From: christopher jones <chris-impact@live.co.uk>
Sent: 04 September 2026 08:24:42 UTC+01:00
To: "Amber Jones" <amber-jonesprojects@outlook.com>; "Anna Tidey" <anna.tidey@midsussex.gov.uk>
Subject: Re: Request for Amended Plan for DM/26/1532 - 7 Nye Road, Burgess Hill
Attachments: Planning drawing 170626.pdf

From: Anna Tidey <anna.tidey@midsussex.gov.uk>
Date: 3 September 2026 at 17:11:35 BST
To: Amber Jones <amber-jonesprojects@outlook.com>
Subject: RE: Request for Amended Plan for DM/26/1532 - 7 Nye Road, Burgess Hill

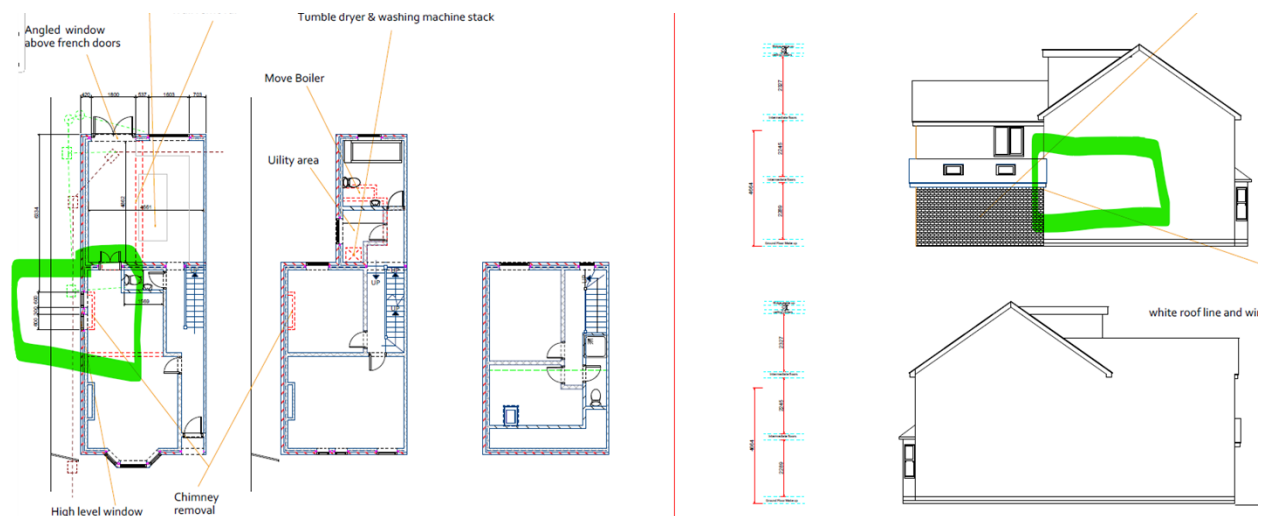
I have started to write my recommendation report for the above application. I have noticed that the Proposed ground floor plans show the insertion of two new windows in the side wall of the house, but these are missing from the Proposed side elevation, see areas marked in green below:

In order to ensure that the Elevation plans reflect the Floor Plans, please can you update and send me the revised drawings?
I will not be able to complete my recommendation until I receive the Amended Plans.
I look forward to hearing from you.
Regards
Anna
